TECH TIPS — Subject: Rattle Noise from Engine
Model: 2007 XVS1300 (V-Star 1300/V-Star 1300 Tourer)

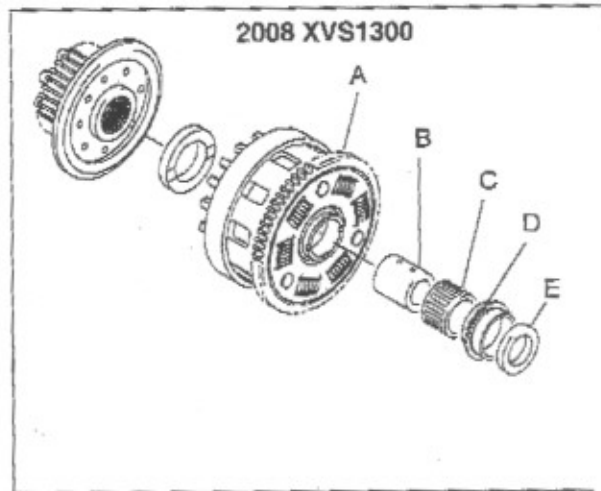
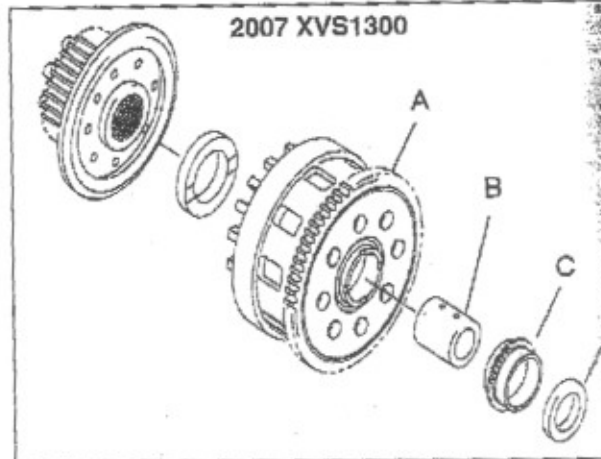
The primary driven gear damper was changed on 2008 models from a rubber cushion type to a spring type to reduce rattle noise. In addition, the 2008 model primary driven gear has slightly more gear lash to reduce whine noise.

The 2007 model primary driven gear will be superseded to a kit containing the 2008 parts in the table below:

Ref.	Parts Name	2007 Model	99999-03812-00 Driven Gear Ass'y Set
A	Primary Driven Gear Comp.	3D8-16150-00-00	3D8-16150-10-00
B	Collar	90387-26009-00	90387-26006-00
C	Bearing	NA	93310-33560-00
D	Sprocket, Drive	3D8-13354-00-00	3D8-13354-10-00
E	Plate, Thrust 2	3D8-16164-00-00	3D8-16164-10-00
